Addendum No. 1

PROJECT: Phase 1 Lower Level Improvements for the
for the Beekman Library

PROJECT N°: 22•46•09

DATE: 3 October 2023

2 ENLARGED PARTIAL
REFLECTED CEILING
PLAN REVISED

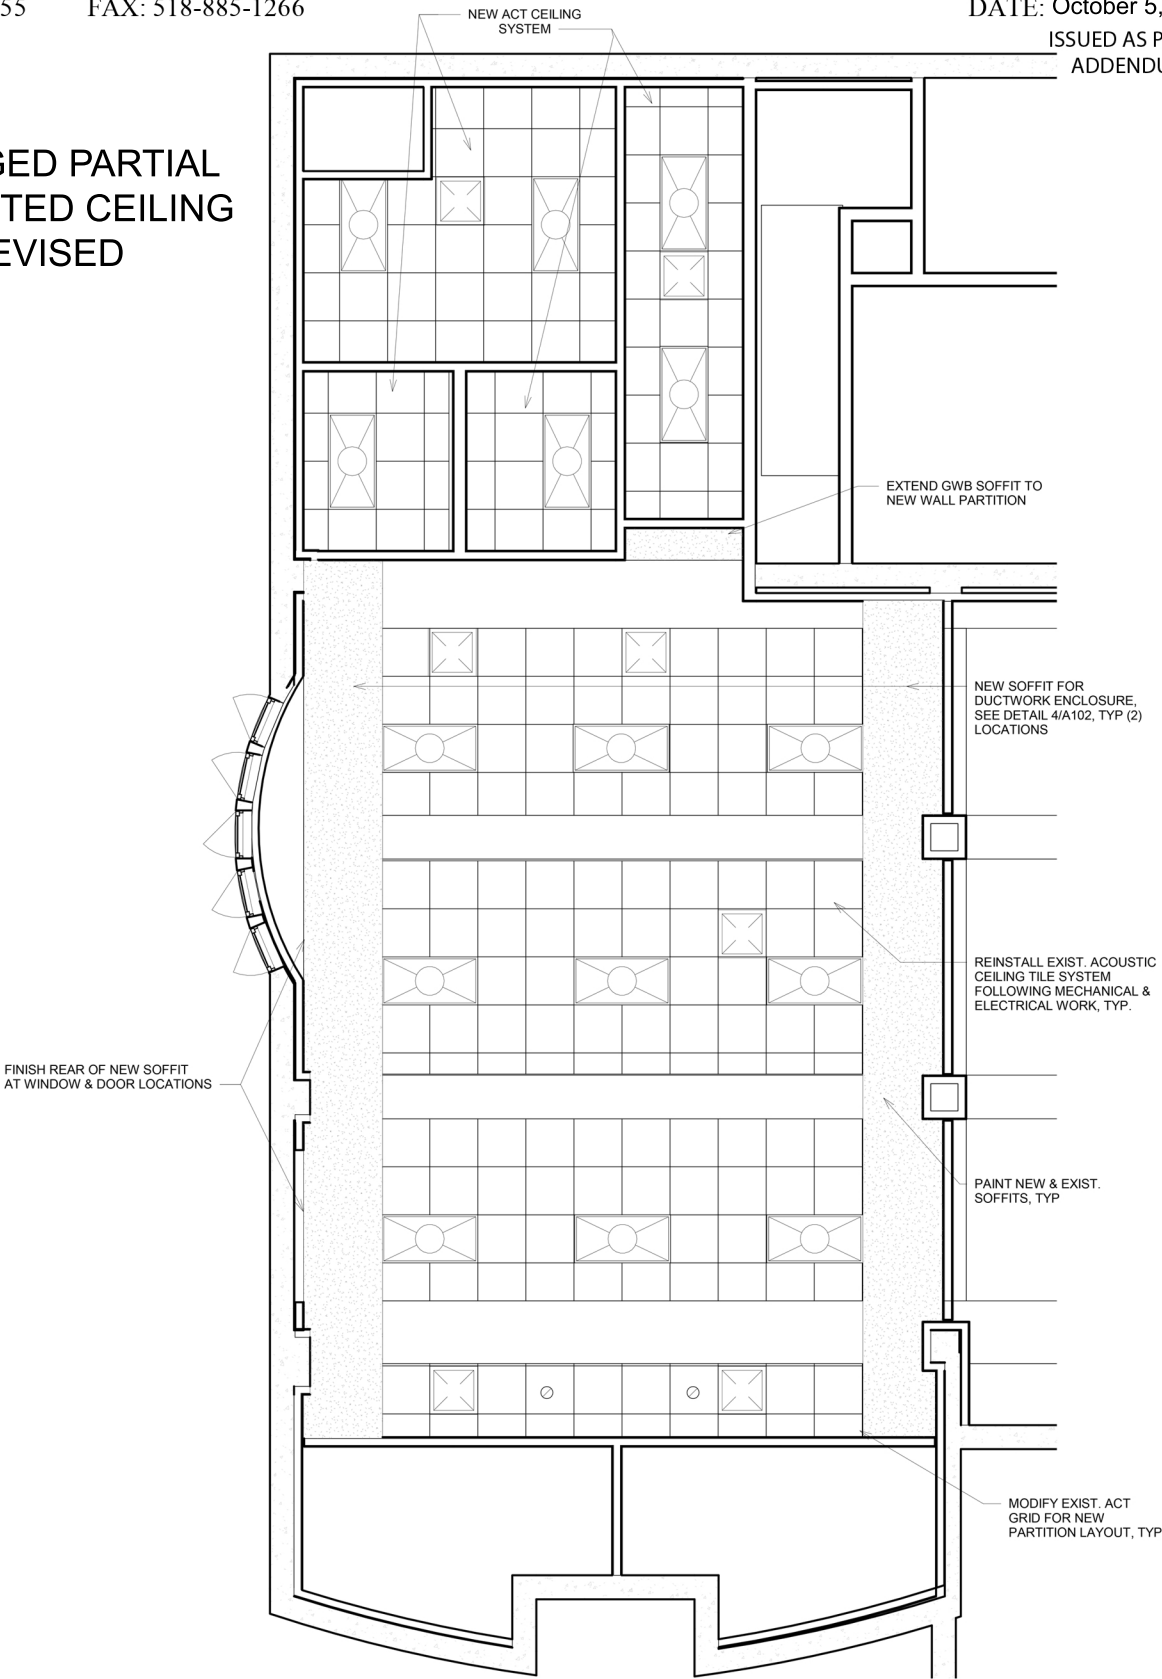
- 5. 2 / A102 Enlarged Partial Reflected Ceiling Plan**
Replace Drawing 2/A102 Enlarged Partial Reflected Ceiling Plan with attached Sketch 2/A102R "Enlarged Partial Reflected Ceiling Plan Revised."

4 TYPICAL MECHANICAL SOFFIT DETAIL
Not to Scale

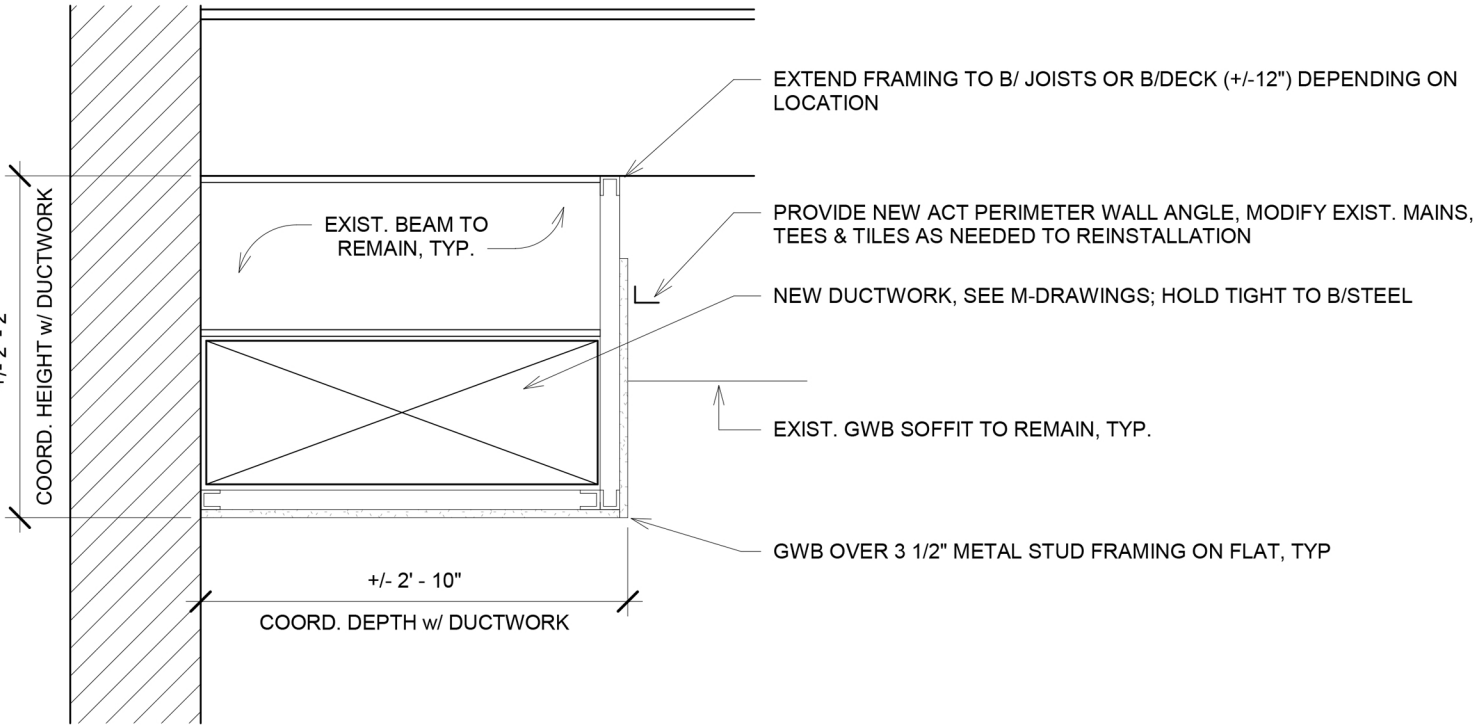
- 3. 1 / A101 Enlarged Exist. Conditions Reflected Ceiling Plan**
Add note at all soffit locations: "Remove existing soffit and pilaster gwb and framing as required to install new ductwork and soffit."

- 6. A102 Enlarged Plans**
Add attached Sketch Detail SK A102-4 as Detail 4/A102 "Typical Mechanical Soffit Detail."
- 7. M101 – HVAC Basement Plan**
Replace Sheet M101 in entire with attached M101R.

5 CONCRETE PAD DETAIL

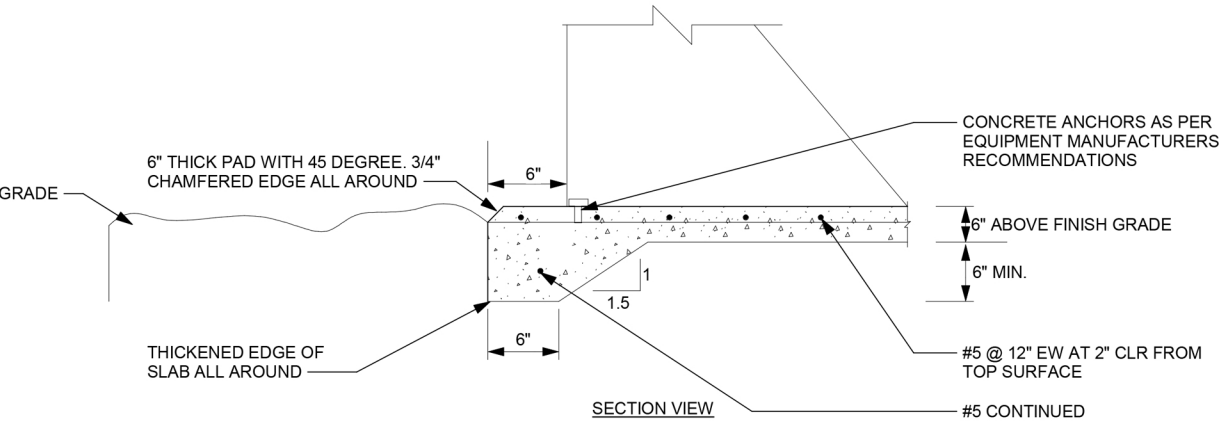
- 8. M501 Mechanical Details**
Add attached Sketch Detail SK M501-5 as Detail 5/M501 "Concrete Pad Detail."
- 9. M501 Mechanical Details**
Add attached Sketch Detail SK M501-6 as Detail 6/M501 "Typical Suitcase Style Condensing Unit Layout Detail."

CONCRETE:
MINIMUM 28 DAY COMPRESSIVE STRENGTH - 3000 PSI
MINIMUM CEMENT FACTOR - 5.5
94 LB SACKS PER CUBIC YARD OF CONCRETE
MAXIMUM AGGREGATE SIZE - 1"
MAXIMUM SLUMP - 4"
ADMIXTURES: WATER REDUCING AGENT
AIR ENTERING AGENT (4% - 6%)

REINFORCING STEEL MATERIALS:
A. REINFORCING BARS - NEW BILLET STEEL
ASTM A-165 GRADE 60
B. WELDED WIRE MESH REINFORCING - COLD
DRAWN WIRE PER ASTM A-185
C. REINFORCING STEEL AND WIRE MESH TO BE
UNPAINTED, UNCOATED, FREE FROM RUST,
SCALE AND OIL.

DETAIL NOTES:
A. TOP SURFACE SHALL BE TROWL FINISHED.
